Village of Arlington Heights  
Plan Commission  
Virtual Meeting  
July 22, 2020  
7:30 PM

- A. Mariano's Gas Station - 406 E. Northwest Hwy. - PC#20-009  
Special Use Permit for Auto Service Station, Variations

**Project Number:** PC 20-009  
**Project Title:** Mariano's Gas Station  
**Address:** 406 E. Northwest Highway  
**PIN:** 03-29-351-009

**To:** Plan Commission  
**Prepared By:** Sam Hubbard, Development Planner  
**Meeting Date:** July 22, 2020  
**Date Prepared:** July 17, 2020

MWRD Removable Hood Detail  
Outlet Control Structure Detail

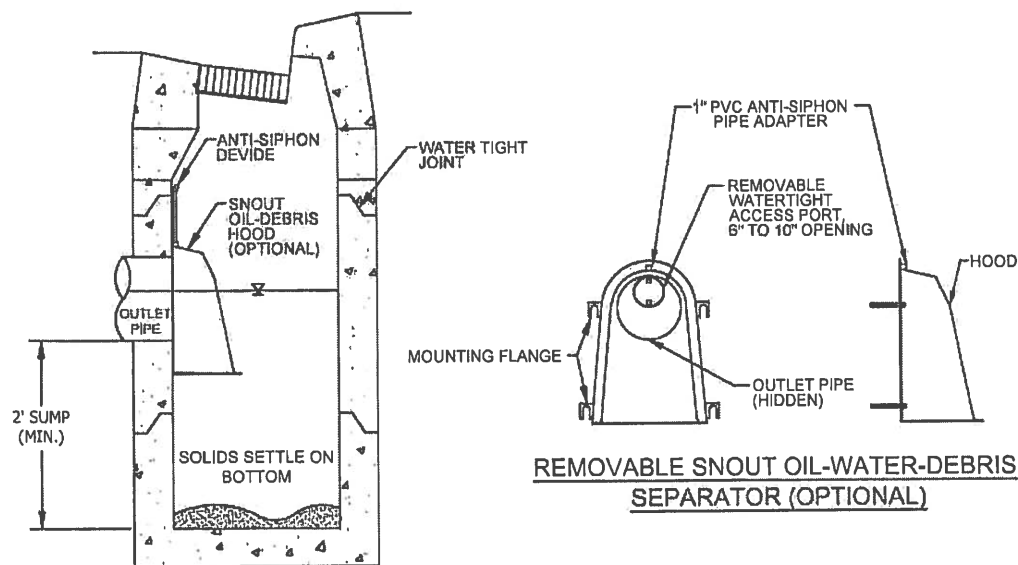
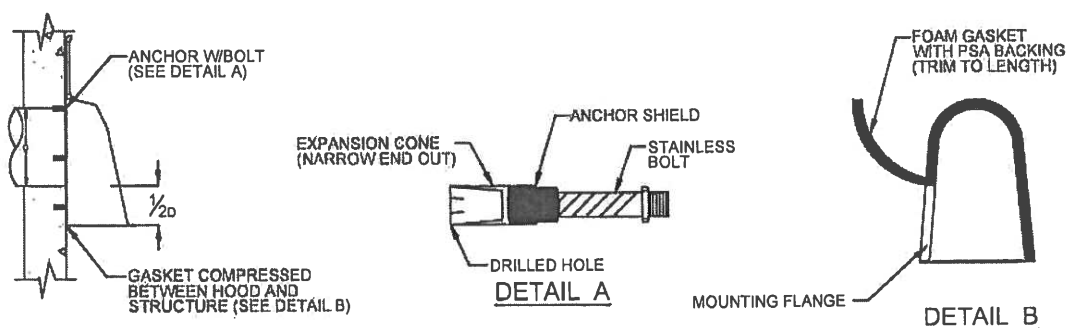
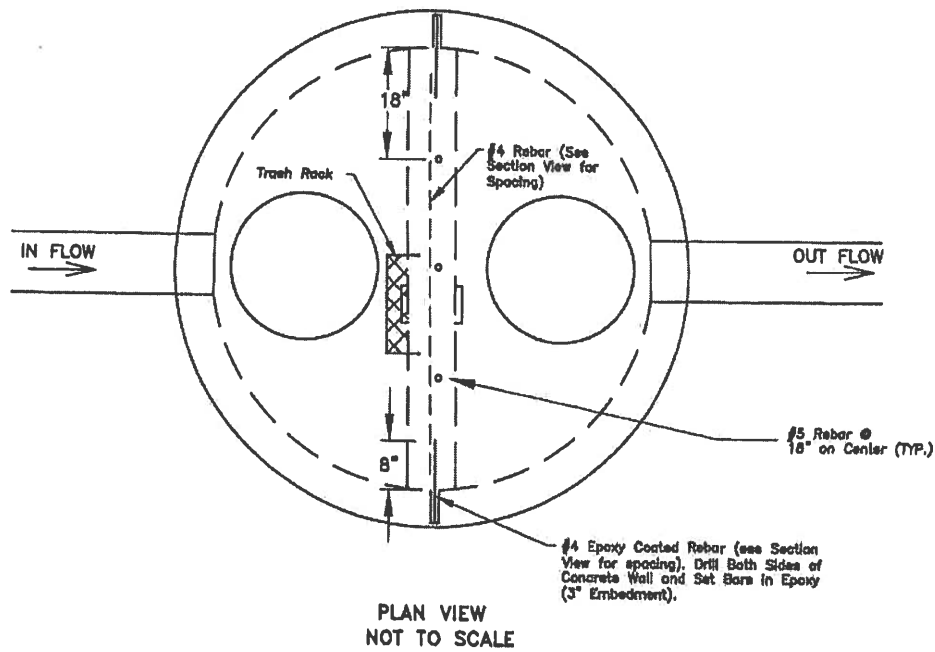
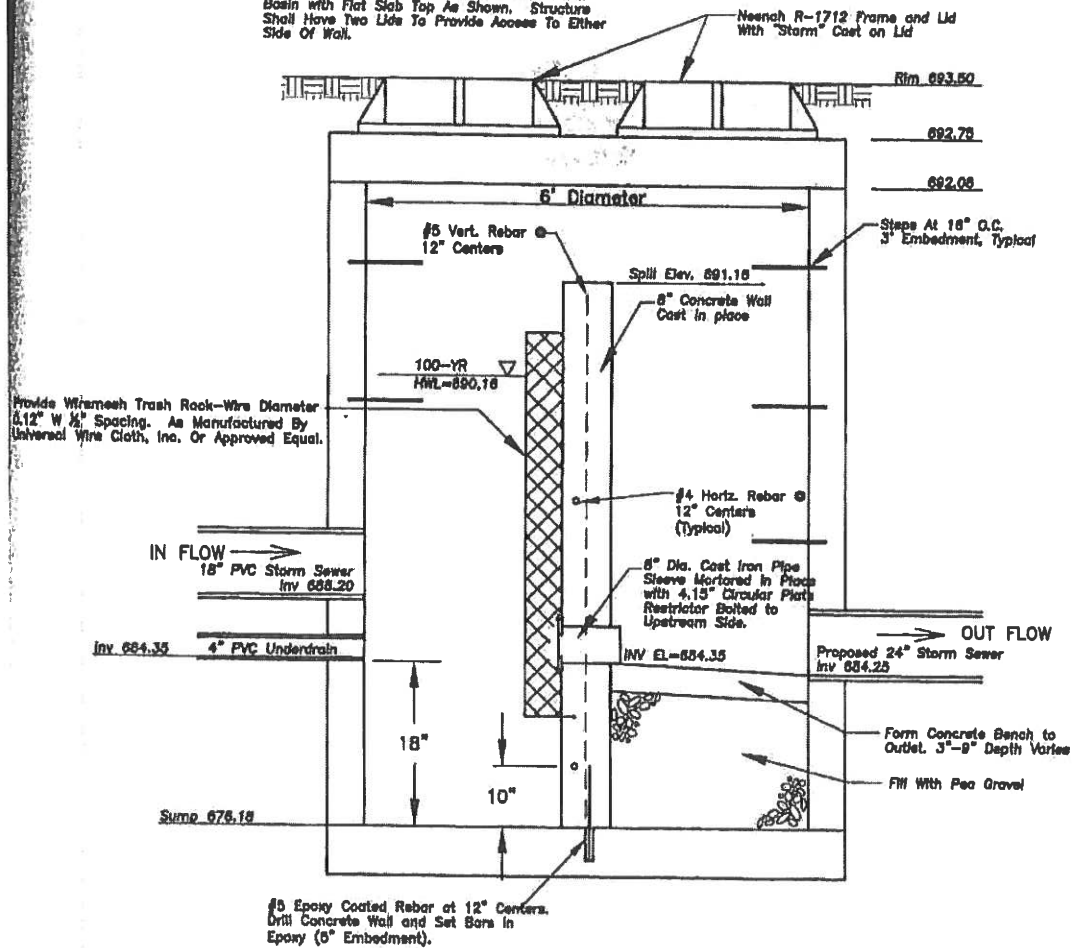
40. The petitioner's response to Comment No. 24 is acceptable.
41. The petitioner's response to Comment No. 25 is noted.
- a. The inverts shown for CB 7 on sheet C 1.31 show a west in elevation at 676.0, south out elevation of 676.5. Verify the inverts for CB 7.

- b. The outlet control structure detail on sheet C 1.31 shows an elevation of 876.0. Revise elevations accordingly.
42. The petitioner's response to Comment No. 26 is acceptable.
